# McLaren Artura - Dielectric Pump Clearance Inspection

<b>Bulletin type:</b>	Service Campaign
<b>Reference number:</b>	N/A
<b>Campaign reference:</b>	SCB 16 G 002
<b>Attention:</b>	Retailer Aftersales Managers, Retailer Service Managers, Retailer Service Advisors, Retailer Technicians, Retailer Parts Managers
<b>Affected vehicles:</b>	McLaren Artura
<b>Situation:</b>	Dielectric fluid pump clearance inspection and adjustment if required
<b>Procedure:</b>	Action affected vehicles during next Retailer visit. Please refer to the information outlined in this document to complete the required work
<b>Date:</b>	10 October 2022

**Image 1** Location of the dielectric pump in proximity to the transmission casing

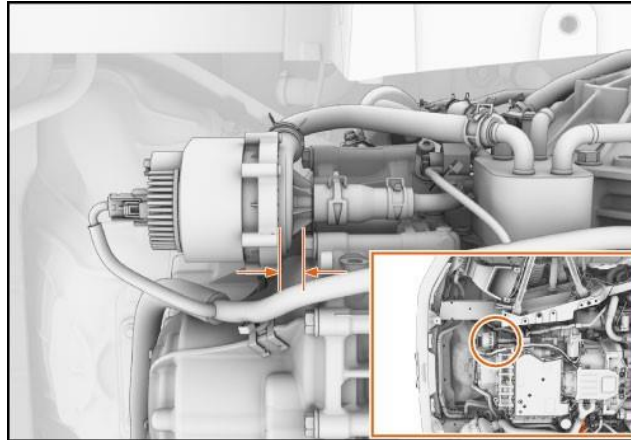
Through continuous product quality monitoring, it has been identified that in certain McLaren Artura vehicles the clearance between the dielectric fluid pump plastic housing and the transmission casing may be incorrect and could cause noise. To eliminate this, McLaren Automotive has released an inspection and rework procedure.
